# **Intel® Desktop Board D865GRH Specification Update**

Release Date: November 2004

Order Number: C59427-007

**Figure 25a. Omnidirectional Airflow Heatsink**

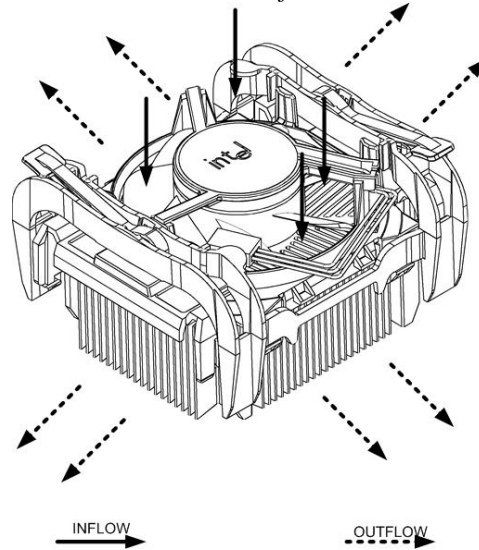
### 3. Change to Thermal Considerations, Section 2.12

Section 2.12, Thermal Considerations will change in its entirety as follows:

- *A chassis with a maximum internal ambient temperature of 38 Degrees Celsius*
- *A processor heatsink that provides omnidirectional airflow so that air is drawn across the processor voltage regulator area (item A in Figure 26). Figure 25a illustrates an omnidirectional airflow heatsink.*

**Figure 26. Localized High Temperature Zones**

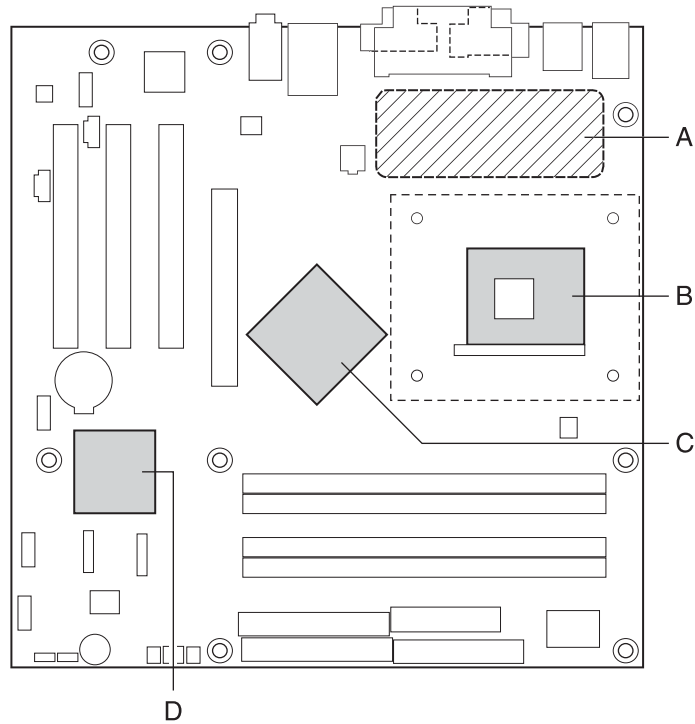
*Ensure that proper airflow is maintained in the processor voltage regulator circuit. Failure to do so may result in damage to the voltage regulator circuit. The processor voltage regulator area (item A in Figure 26) can reach a temperature of up to 85 °C in an open chassis.*

Figure 26 shows the locations of the localized high temperature zones.
